Application by
Fingal County Council
for Waste Licence Application W0231-01
for Fingal Landfill, Co. Dublin

***Replies to Request
for further information in accordance with
Article 14(2)(b)(ii) of the Waste
Management Regulations***

January 2007

Article 14 Information

Notes

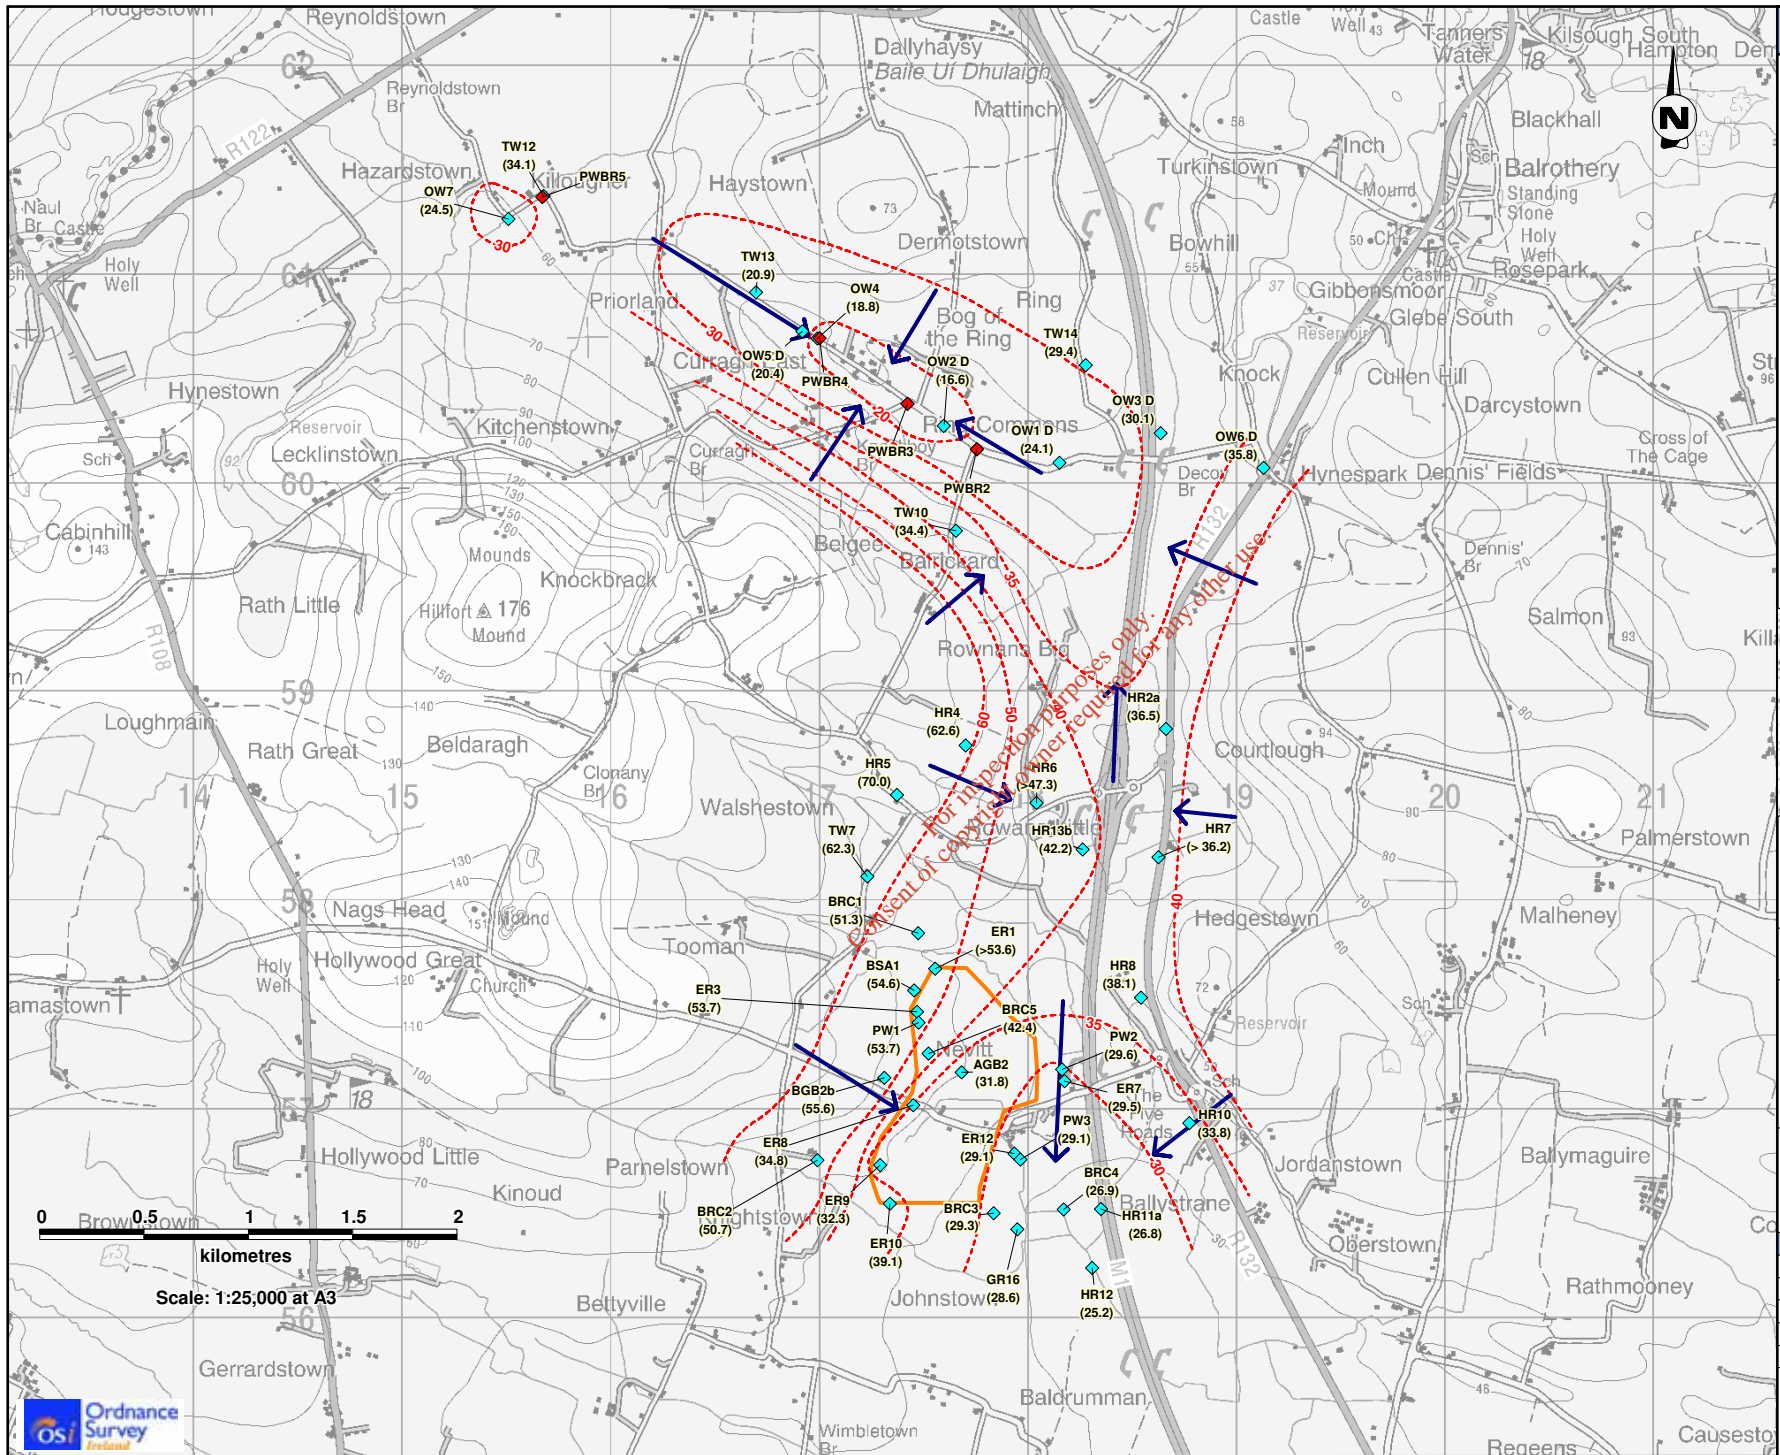
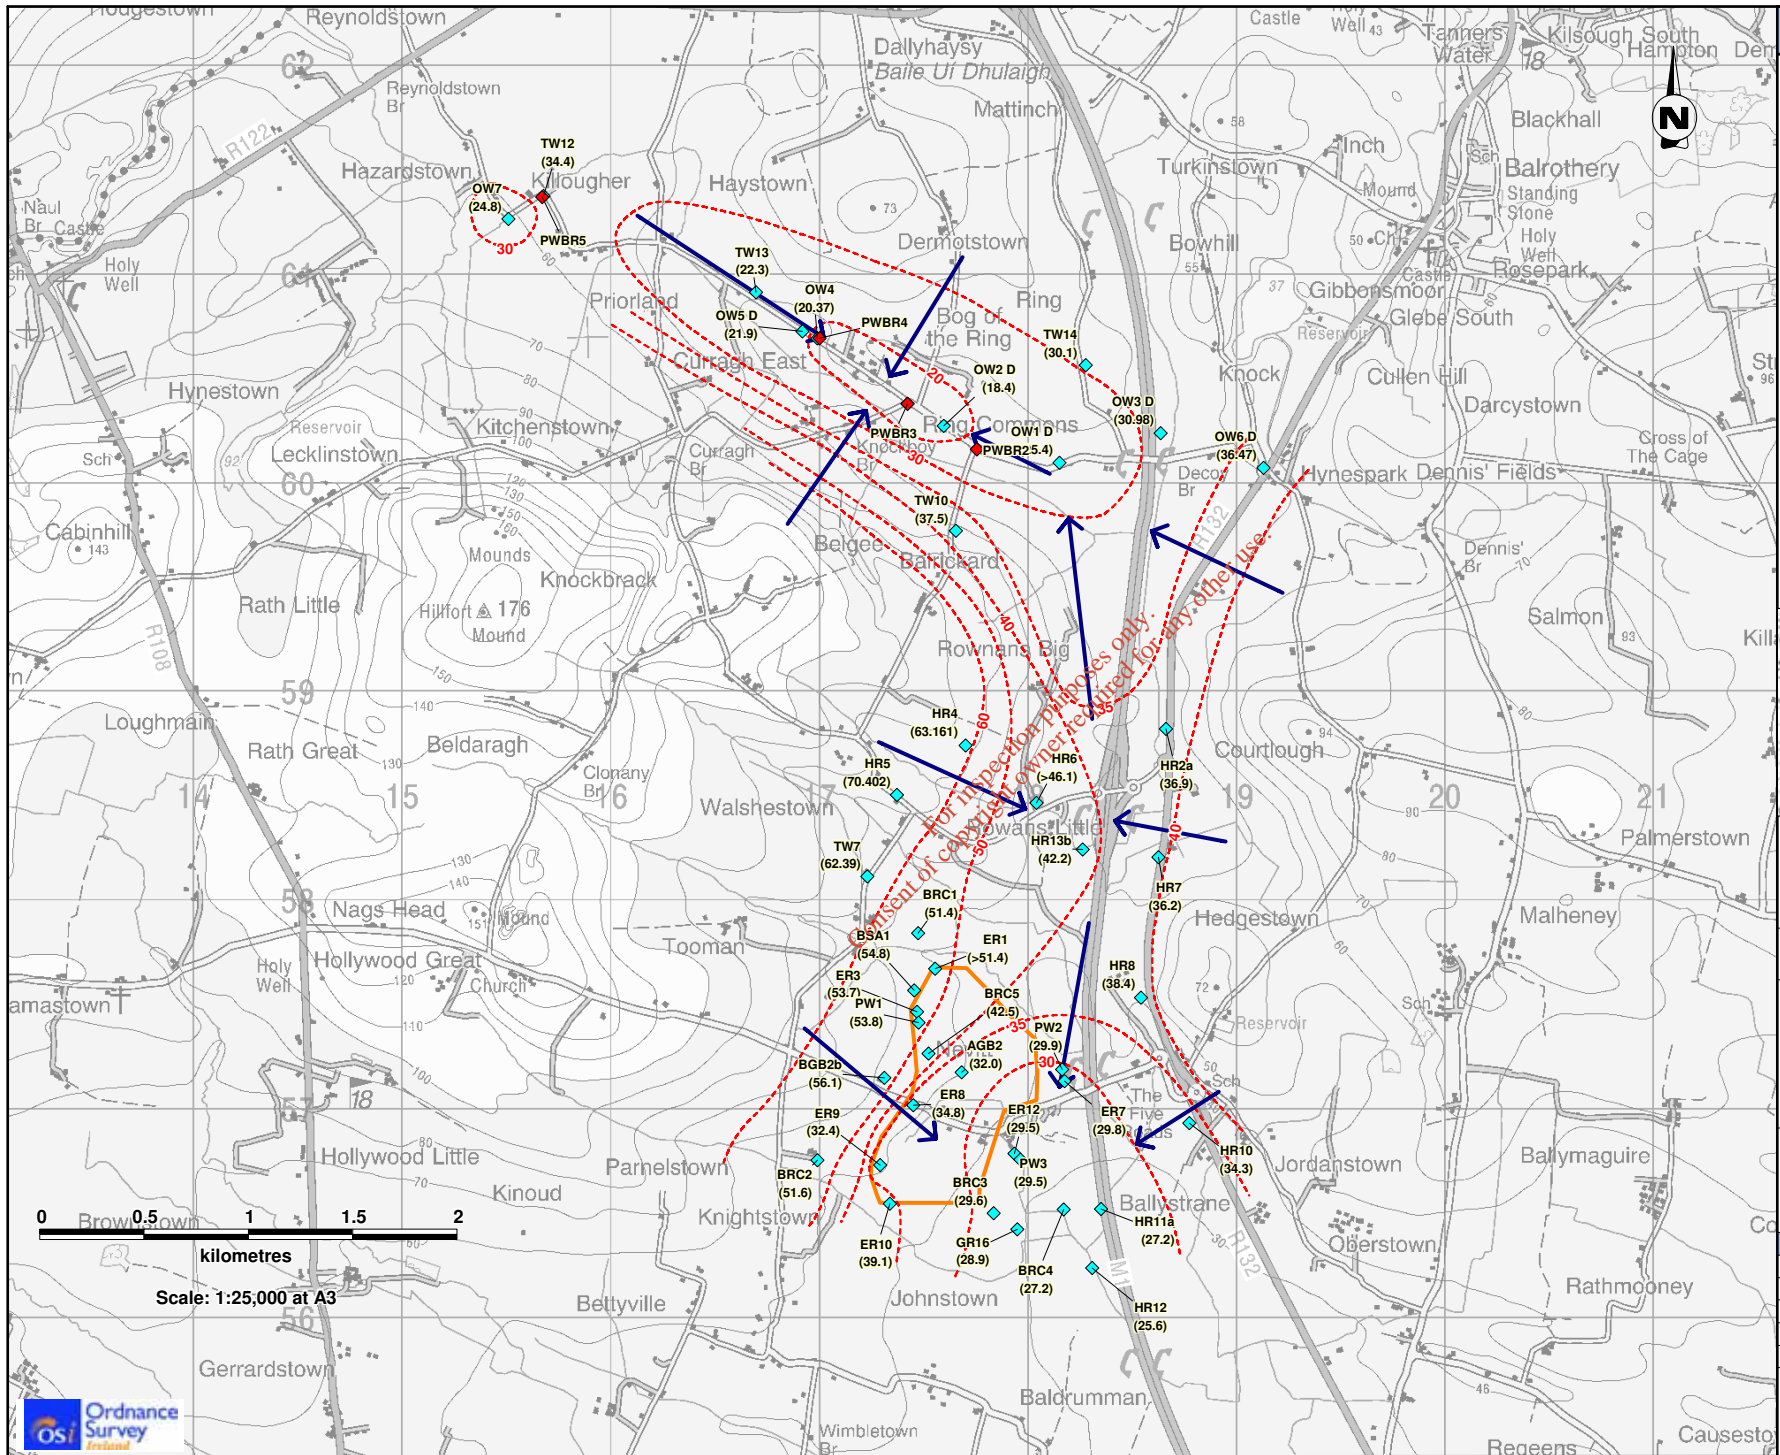
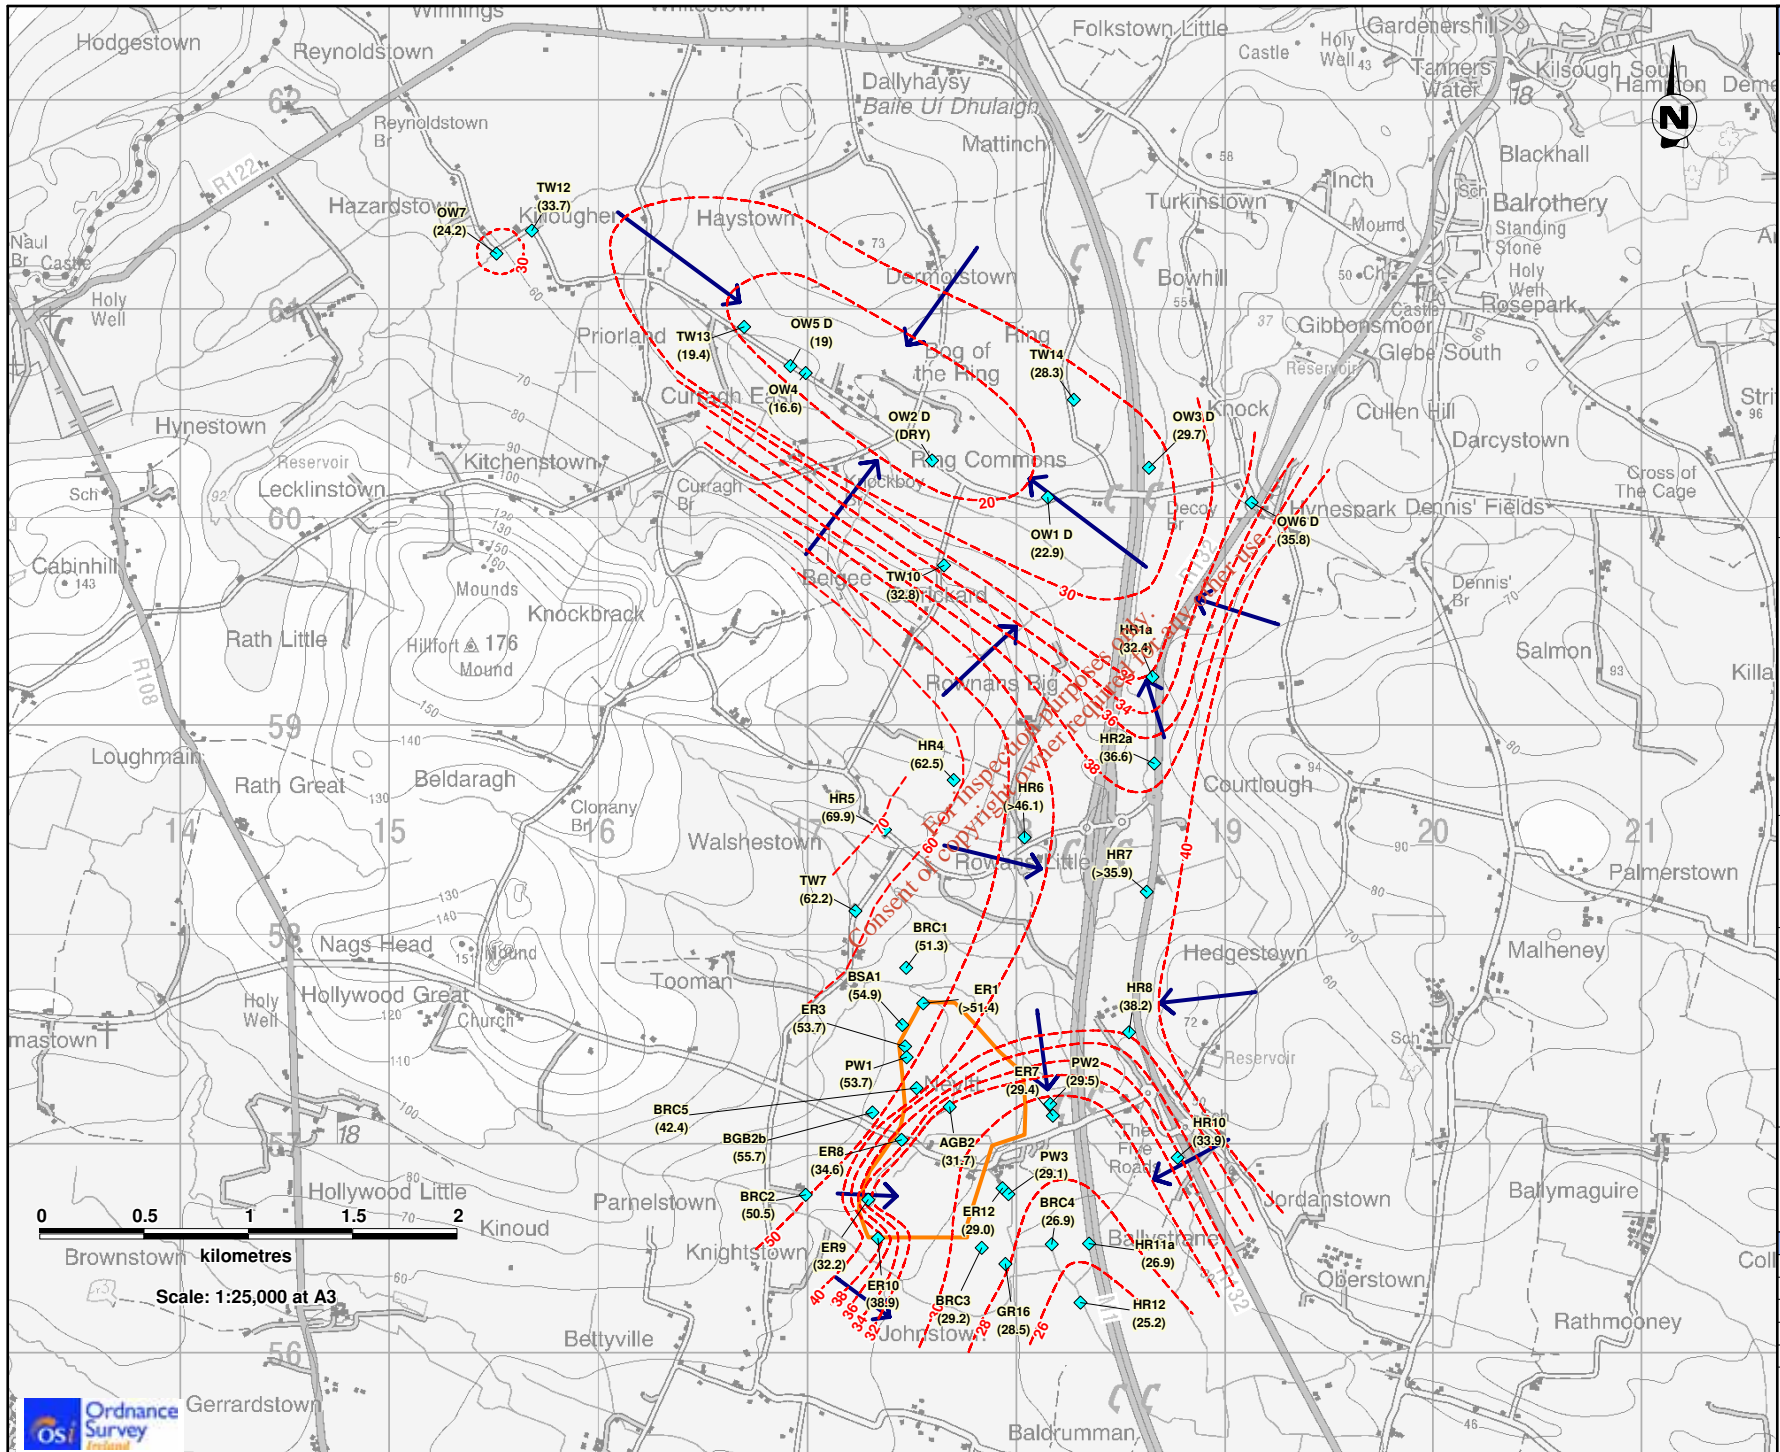
The notice issued by the EPA on October 11th 2006 regarding Article 14 (2) (b) (i) of the Waste Management Licensing Regulations, *Section 1.4 (ii) required a more rigorous assessment of the groundwater flows in the area of abstraction wells P1, P8 and P10.*

Groundwater flow maps are provided in **Appendix 6**. The direction of groundwater flow under the proposed site and local surrounding area has been established from comprehensive time series groundwater level monitoring data. Water level monitoring data sets collected from June 2005 to December 2006 have consistently demonstrated that groundwater flow below the proposed landfill site is in a south-easterly direction towards Rogerstown Estuary and away from the Bog of the Ring through all seasons.

Further to our response to the first notice submitted on the 19th December 2006 in relation to Article 14, a contour map for December 2006, which includes data for Kerrigan's well, is included in **Appendix 6**. It can be seen that the overall groundwater flow direction in that area is to the south east and away from the proposed landfill site. This is consistent with the overall groundwater flow pattern for the area and any groundwater originating beneath the landfill is not likely to flow towards Kerrigan's well.

BOG OF THE RING CONE OF DEPRESSION

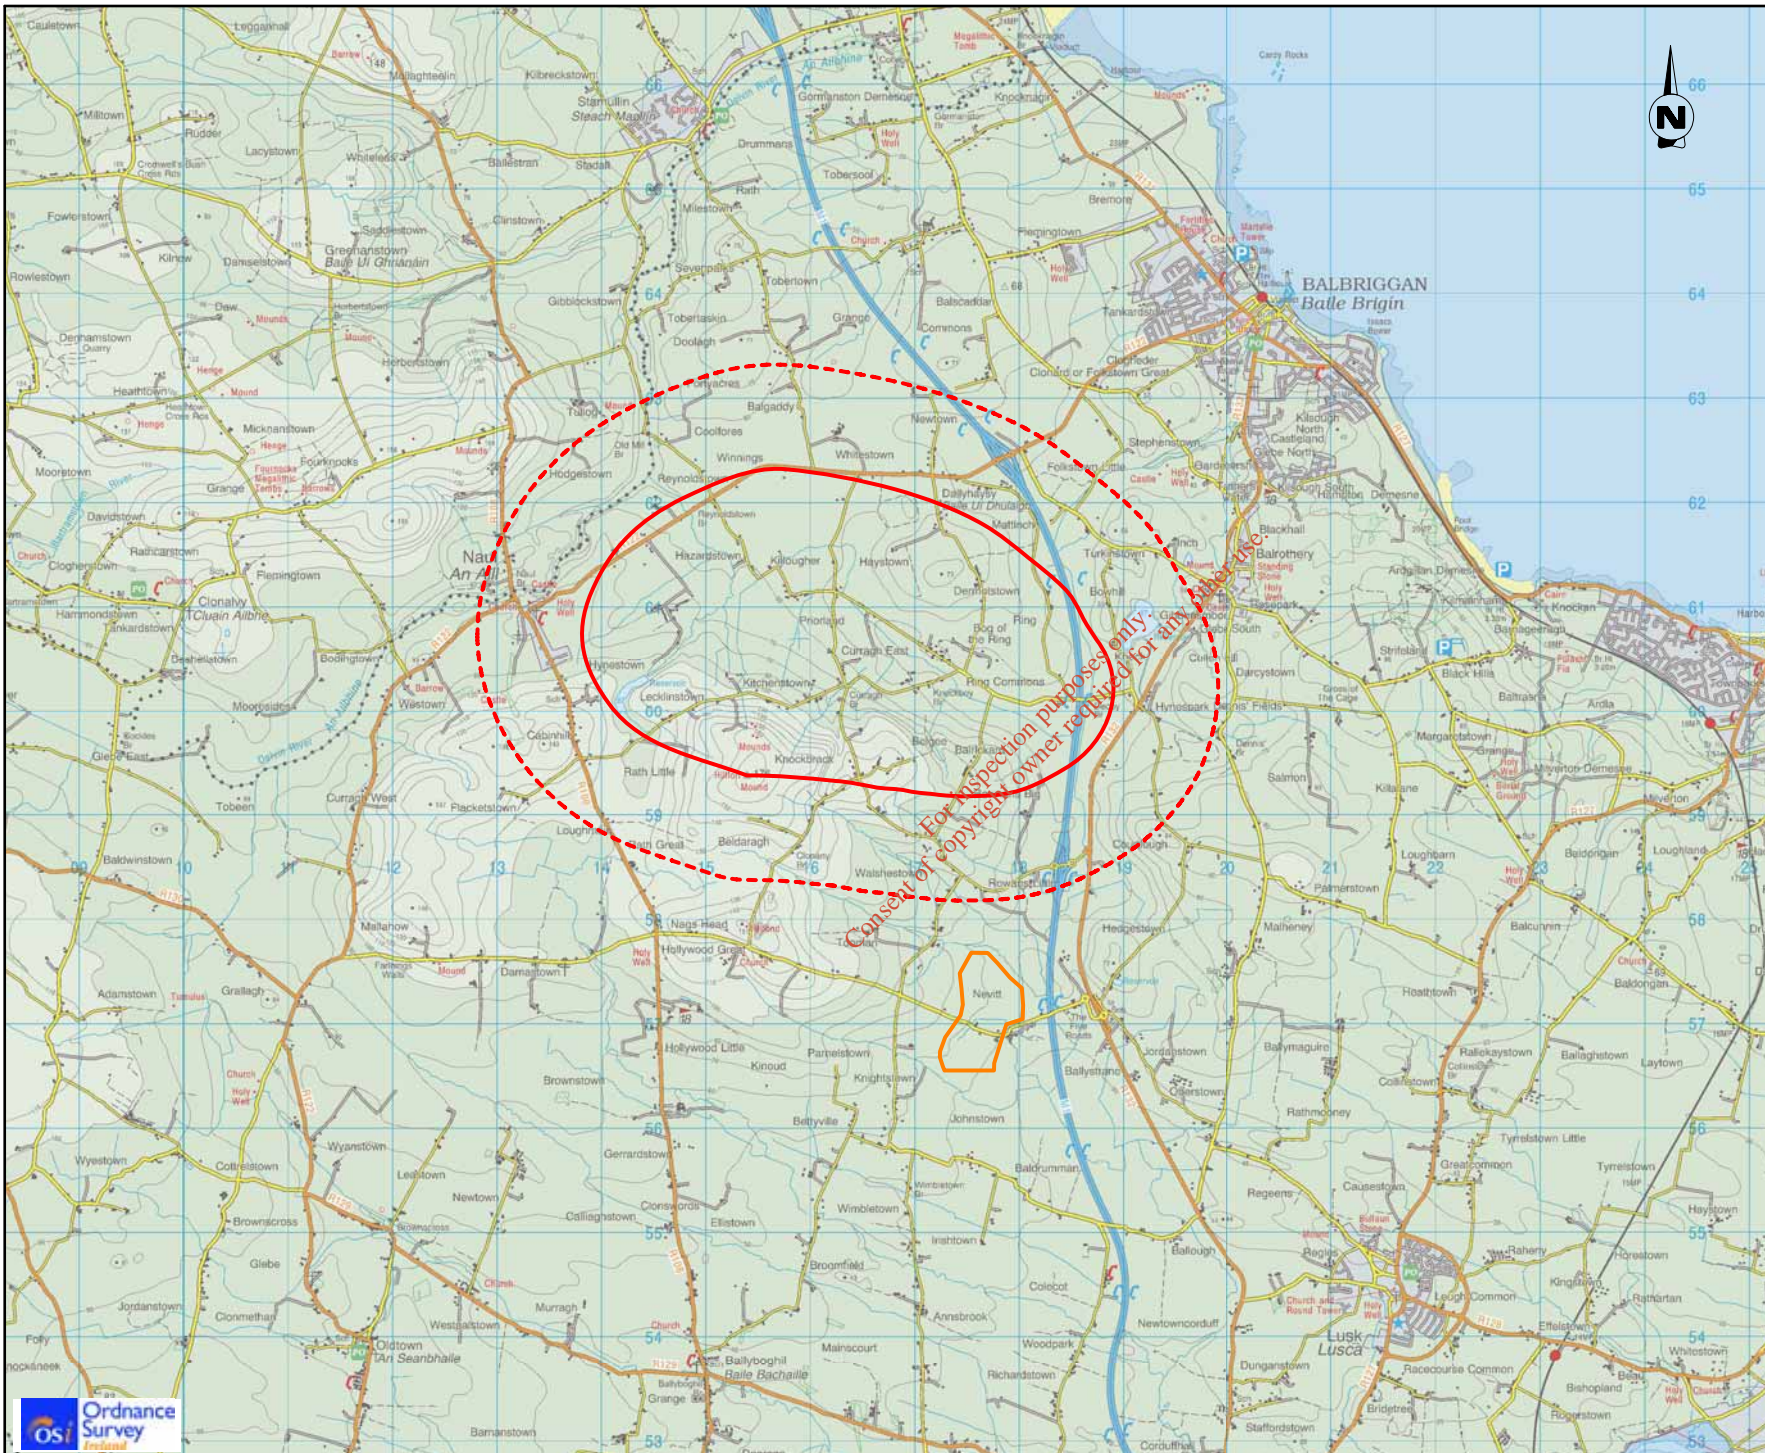
The Mott McDonald report also suggests that the potential seasonal variations in groundwater levels are not adequately assessed in the EIS as the assessment period covers June 2005 to January 2006 (include groundwater levels and flow directions). Include comments on the impact of drought and periods of high rainfall.

Therefore the current cone of depression is considered to be relatively conservative. Under a prolonged drought scenario the cone of depression may expand but there is considerable land area to accommodate this before entering the landfill footprint. Groundwater can also be released from unconfined storage to sustain yields in short term before aquifer recharge occurs. It has been

calculated that the cone of depression could expand by greater than 100% and still retain a 500m buffer to the landfill footprint area. This is shown in **Appendix 7**.
